PURPOSE OF REPORT – TECHNICAL NOTE IN RESPONSE TO

**RESPONSE TO COMMENTS IN RELATION TO CONDITION 8 OF
PLANNING APPROVAL REF: CDN/22/0551**

Version 1.0
Date/Time 06.10.2022

BOWKER SADLER ARCHITECTS, MELLAND HIGH SCHOOL – GORTON EDUCATION VILLAGE

APPENDIX A – PROPOSED DRAINAGE PLAN

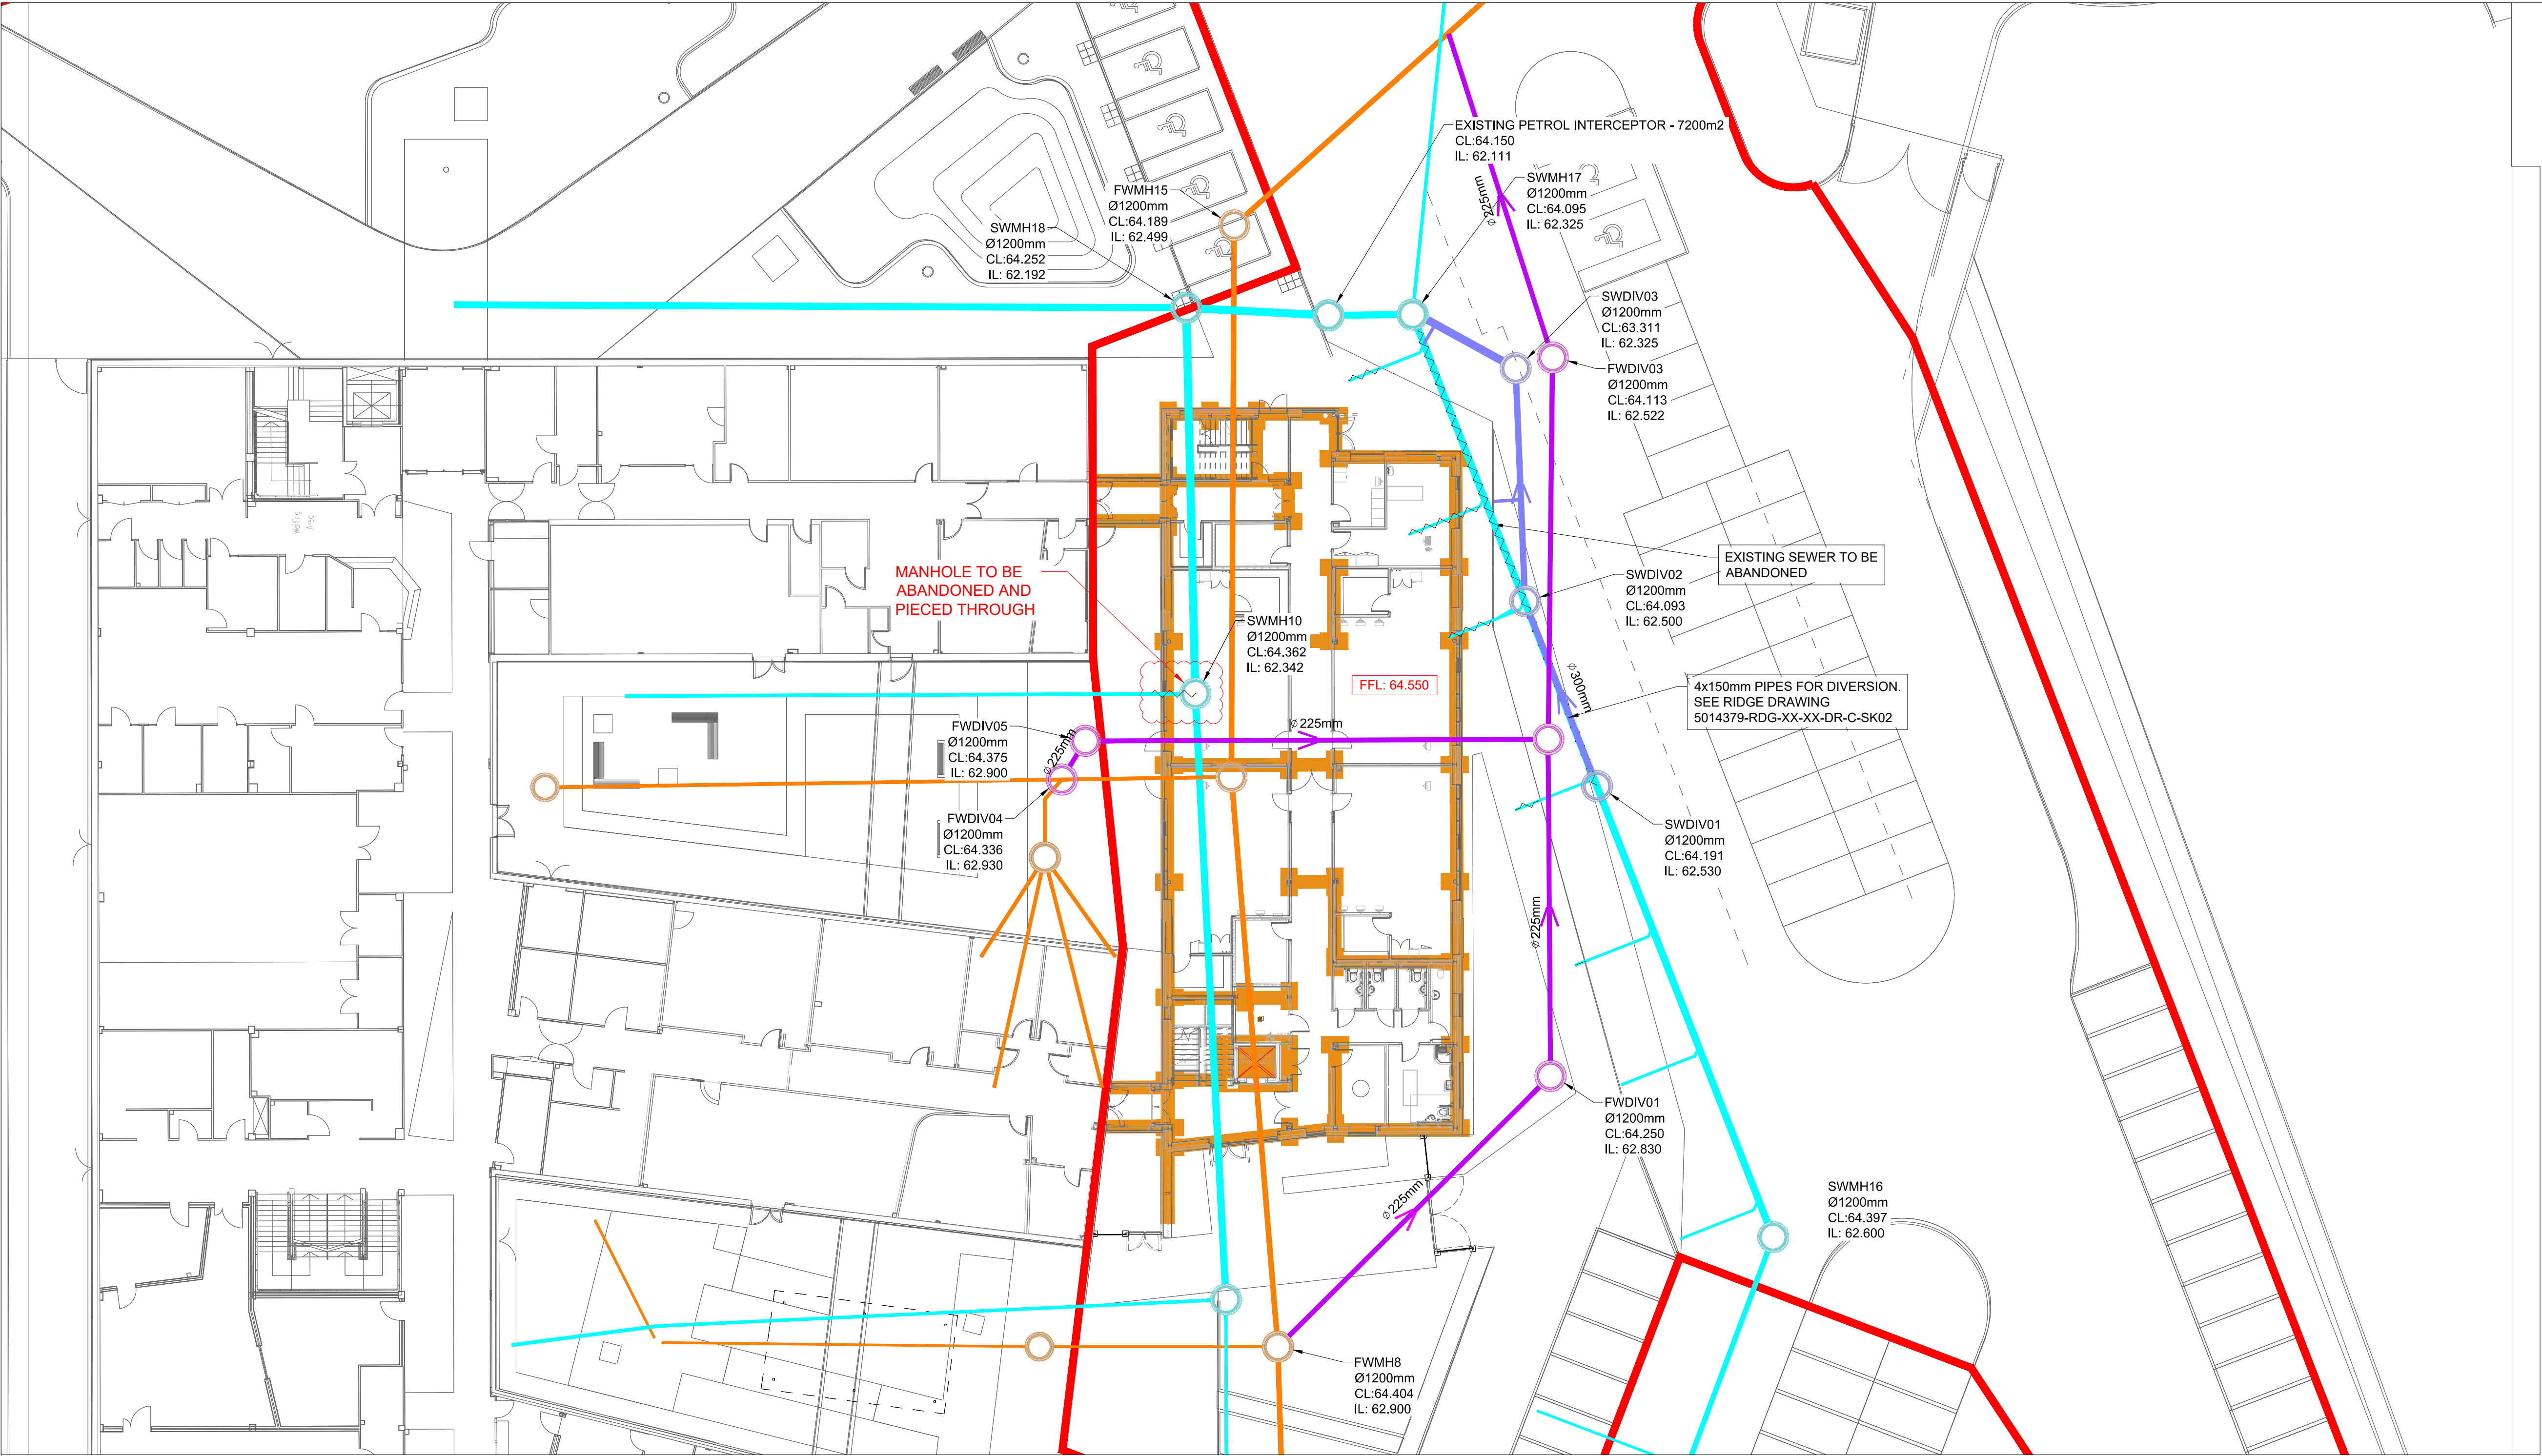
LLFA Comment	Ridge Response
<i>Consideration of alternative green SuDS solution (such as green or blue roofs) if practicable;</i>	Alternative SuDS solutions were considered, however due to the nature of this construction they were not seen as feasible.
<i>The proposed extension clashes with existing surface water drainage on site, measures must be specified as to how the structural integrity of these assets will be maintained.</i>	The existing surface water drain to be built over has been co-ordinated with pile caps and ground beams. The proposed foundations will bridge the SW drain and the ground floor slab is proposed to be suspended. As such, no additional loading will be applied to the drain either during construction or during operation of the building.
<i>Some proposed surface water drainage connections bypass the proposed flow control, all surface water discharge should be controlled by the flow control.</i>	The new surface water drainage connecting downstream of the flow control are existing drains, to be diverted. The surface water plans have been altered to make this clearer, see <i>Appendix A</i> .

<i>Hydraulic calculation of the proposed drainage system;</i>	As above, see <i>Appendix D</i> for the proposed Surface Water drainage model.
United Utilities Comment	Ridge Response
<i>Further to our review of the submitted documents, Drawing 5014379-RDG-ZZ-ST-DR-C-05001, Rev P02- Dated 15/02/2022, United Utilities recommends that condition 8 is not discharged. This is because the drawing shows there is a 100mm surface water sewer drain to network (SWMH18) after the hydro brake manhole. The developer need to redesign the drainage network to achieve a total 5 l/s discharged from the site.</i>	The new surface water drainage connecting downstream of the flow control are existing drains, to be diverted. The surface water plans have been altered to make this clearer, see <i>Appendix A</i> .

C01	CONSTRUCTION ISSUE - SW DIVERSION UPDATED TO SUIT RPI 008 SOLUTION, DIVERSION CONNECTIONS TO SWMH18 MADE CLEAR, ATTENUATION TANK RELOCATED	05.10.22	TP	PB
REV	DESCRIPTION	DATE	BY	CHKD

APPENDIX E – FLOOD EXCEEDANCE DRAWING

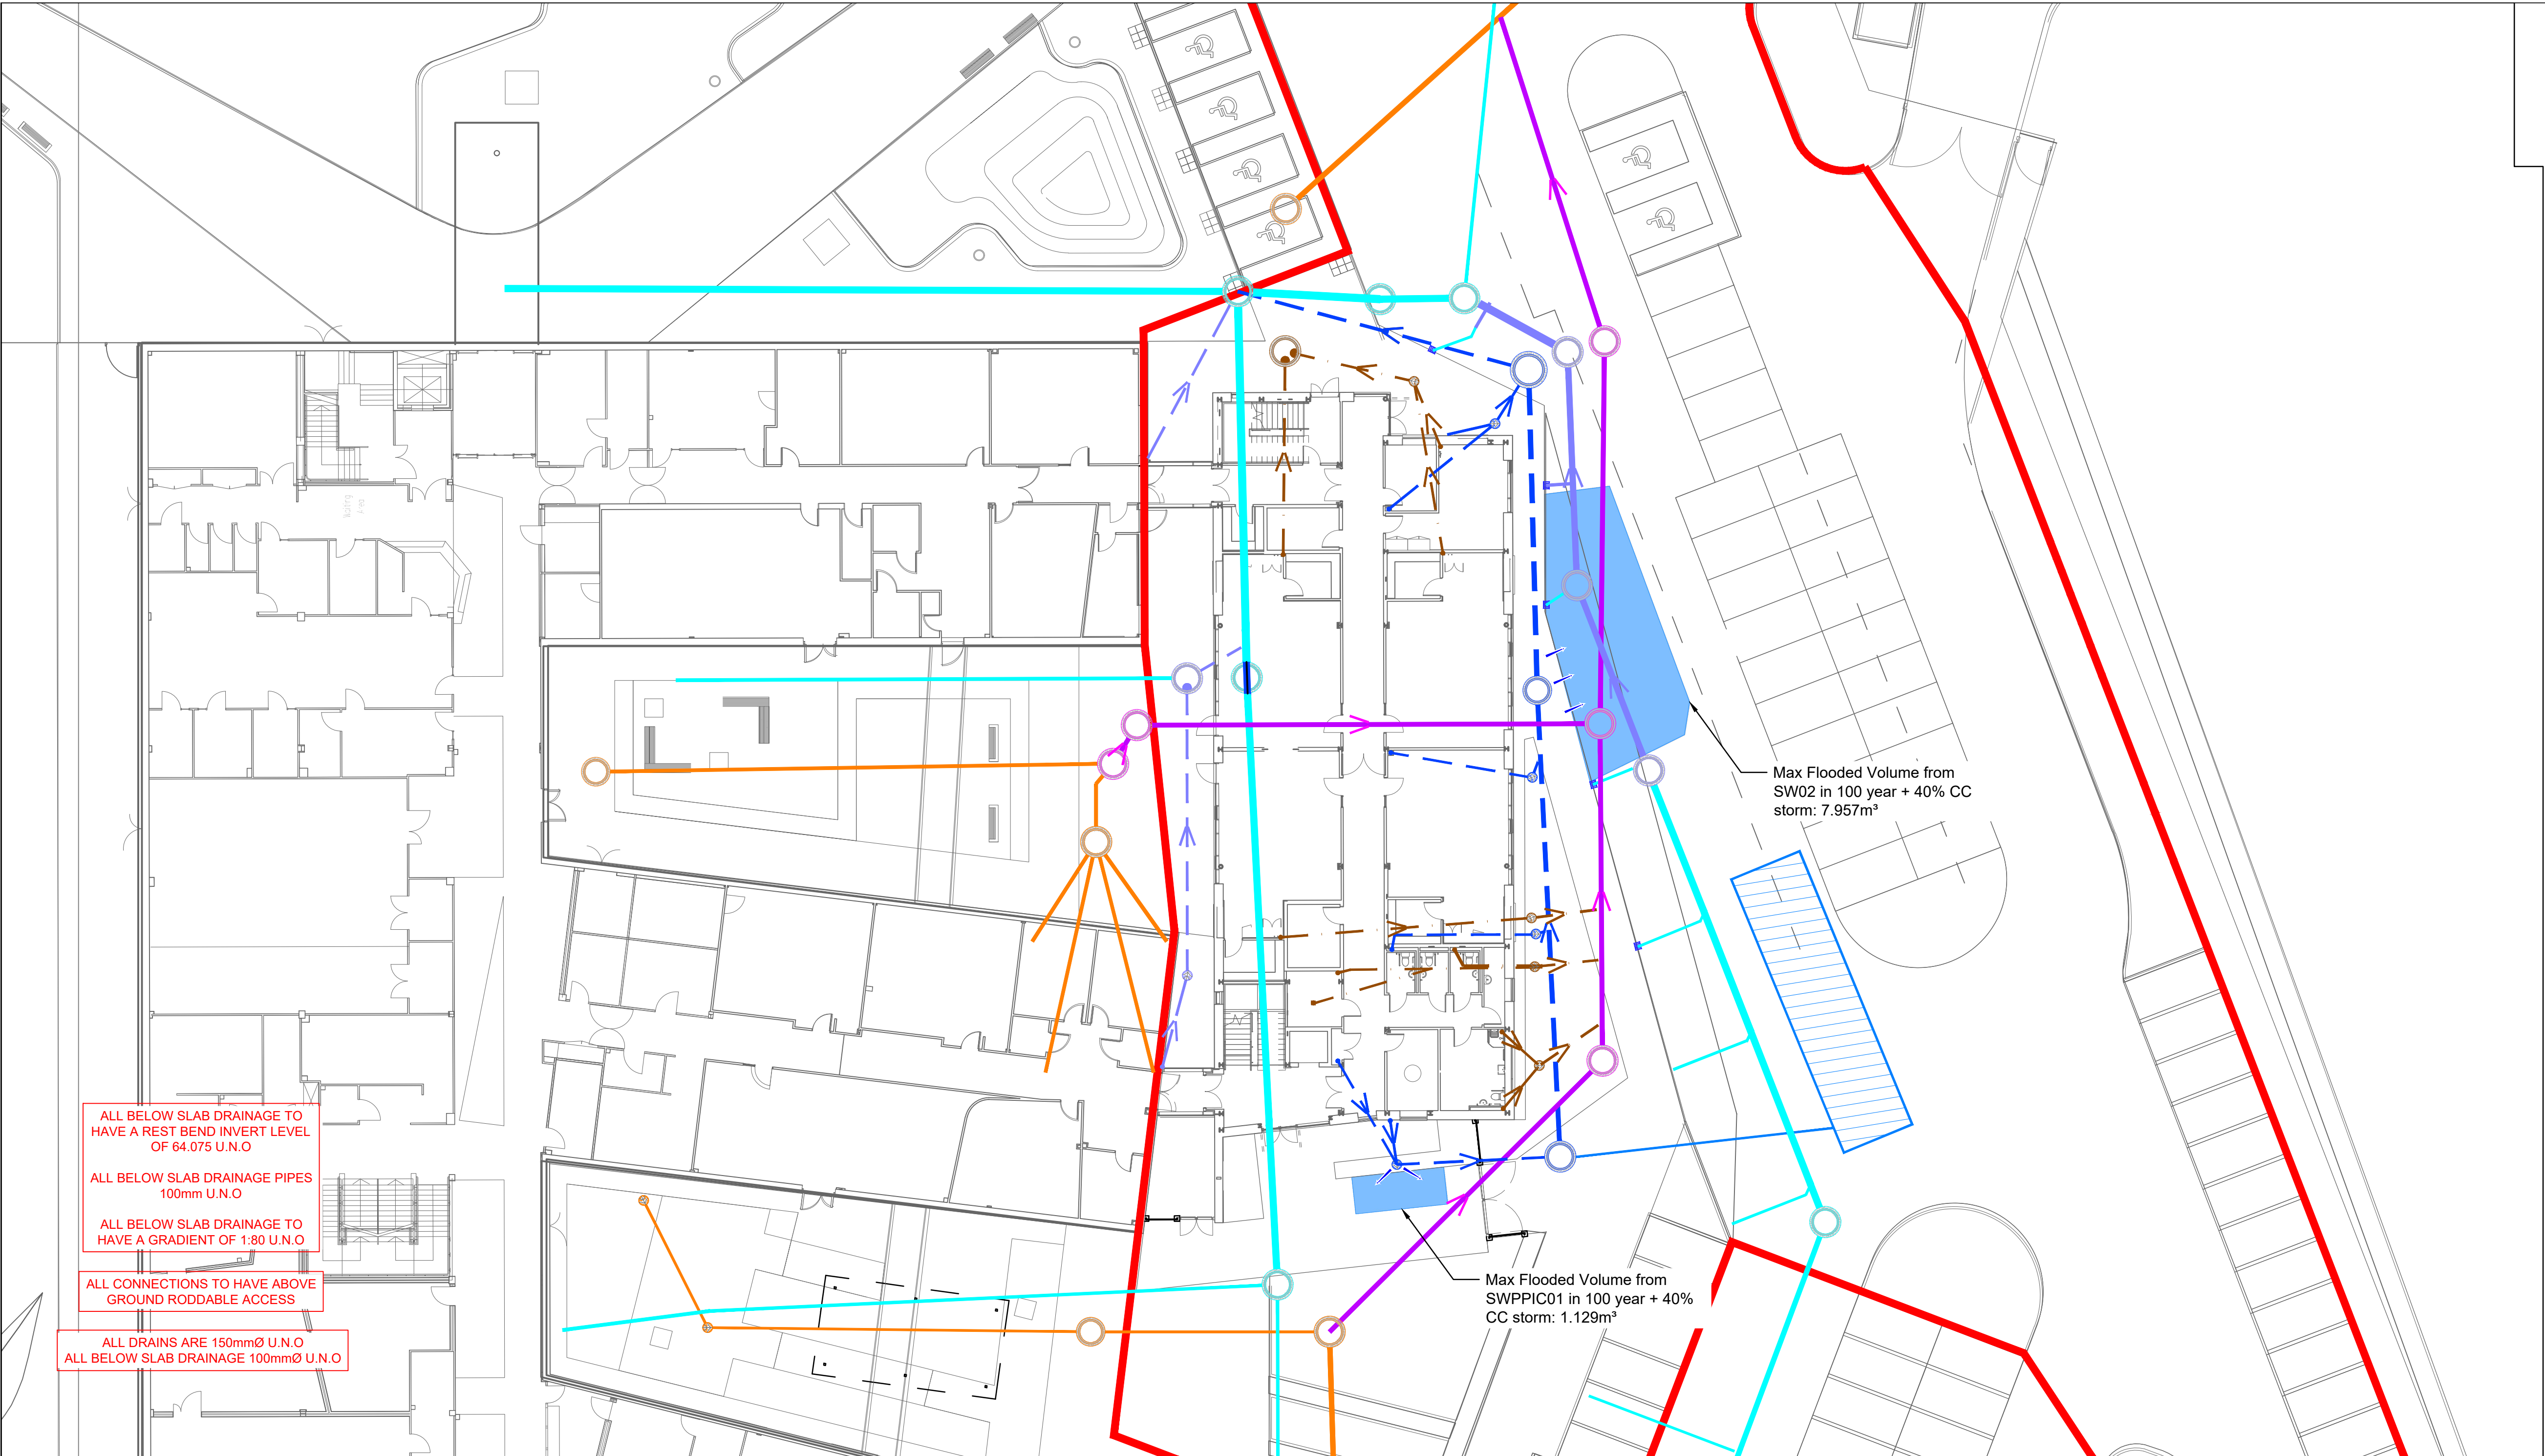
<i>Evidence that the drainage system has been designed (unless an area is designated to hold and/or convey water as part of the design) so that flooding does not occur during a 1 in 100 year rainfall event with allowance for climate change in any part of a building;</i>	See <i>Appendix D</i> for drainage model. The calculations demonstrate that although there is some risk of flooding that occurs during the 100 year + 40% event only, this is restricted to only 8m ³ around SW02 & 1m ³ around SWPPIC01. See <i>Appendix E</i> .
<i>Where an application is part of a larger site it is essential that the new proposal does not compromise the existing drainage. Calculations must be completed to ensure the proposed extension will not cause flooding issues to the surrounding private drainage network.</i>	The drainage has been designed to reduce the current discharge rate of 10.7l/s by more than 50% to 5l/s. The reduction in flow from this part of the site will reduce loading on the existing system, as such will not increase flood risk.
